Well Name: EAGLE 35 L FED	Well Location: T17S / R27E / SEC 35 / NWSW /	County or Parish/State: EDDY / NM
Well Number: 2	Type of Well: OIL WELL	Allottee or Tribe Name:
Lease Number: NMLC064050A	Unit or CA Name:	Unit or CA Number:
US Well Number: 300152963300S1	Well Status: Producing Oil Well	Operator: REDWOOD OPERATING LLC

Type of Action: Plug and Abandonment

## Plug Abandonment NOI Proposed

<b>OPERATOR NAME:</b>	Redwood Operating LLC
<b>LEASE NO.:</b>	NMLC064050-A
<b>WELL NAME &amp; NO.:</b>	Eagle 35 L Federal #2
<b>US WELL NUMBER:</b>	30-015-29633
<b>LOCATION:</b>	Sec 35, T17S, R27E
<b>COUNTY:</b>	Eddy County, NM

Redwood Operating, LLC		CURRENT	
Author:	Abby @ BCM	Well No.	#2
Well Name	Eagle 35 L Federal	API #:	30-015-29633
Field/Pool	Red Lake; (Q-GB-SA)	Location:	Sec 35, T17S, R27E
County	Eddy		1820 FSL & 960 FWL
State	New Mexico	GL:	3609
Spud Date	9/2/1997

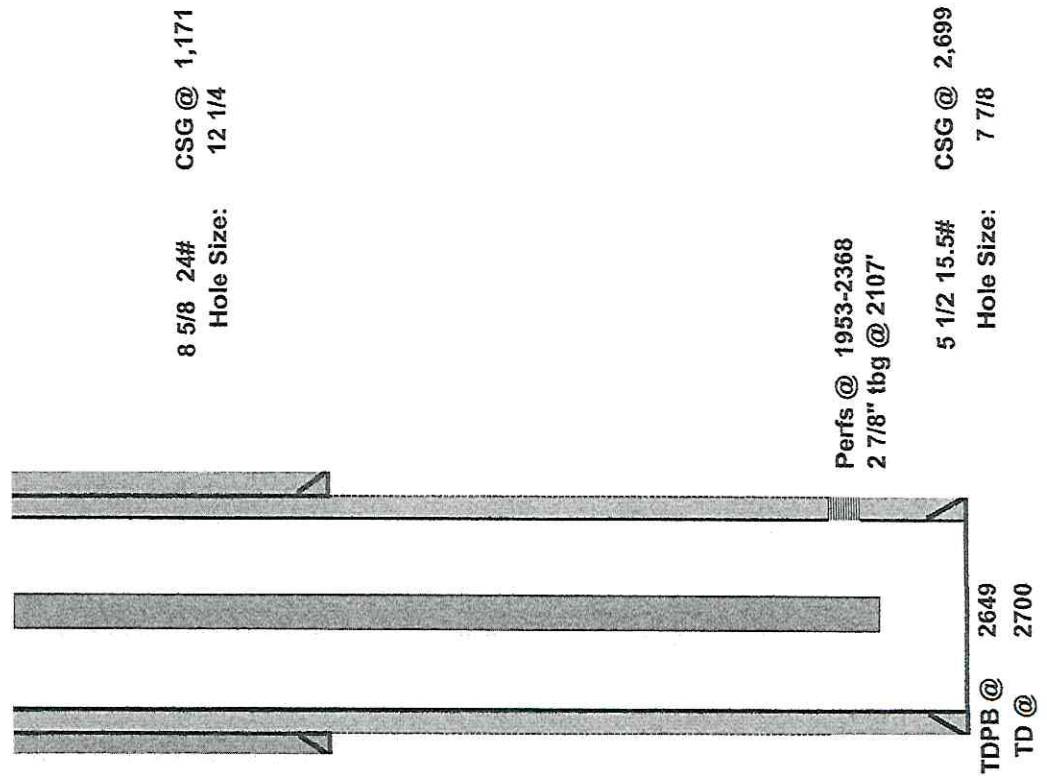
3. Spot 25 sx cmt @ 200' to surface.

55 sx 498'

1. Set 5 1/2" CIBP @ 1903'. Circ hole w/ MLF. Pressure test csg. Spot 25 sx cmt @ 1903-1703'.
2. Spot 25 sx cmt @ 1221-1021'. WOC & Tag (8 5/8" Shoe)
3. Spot ~~25~~ sx cmt @ ~~200~~' to surface. *55 sx 498' to surface.*
4. Cut off well head, verify cmt @ surface, weld on Dry Hole Marker.
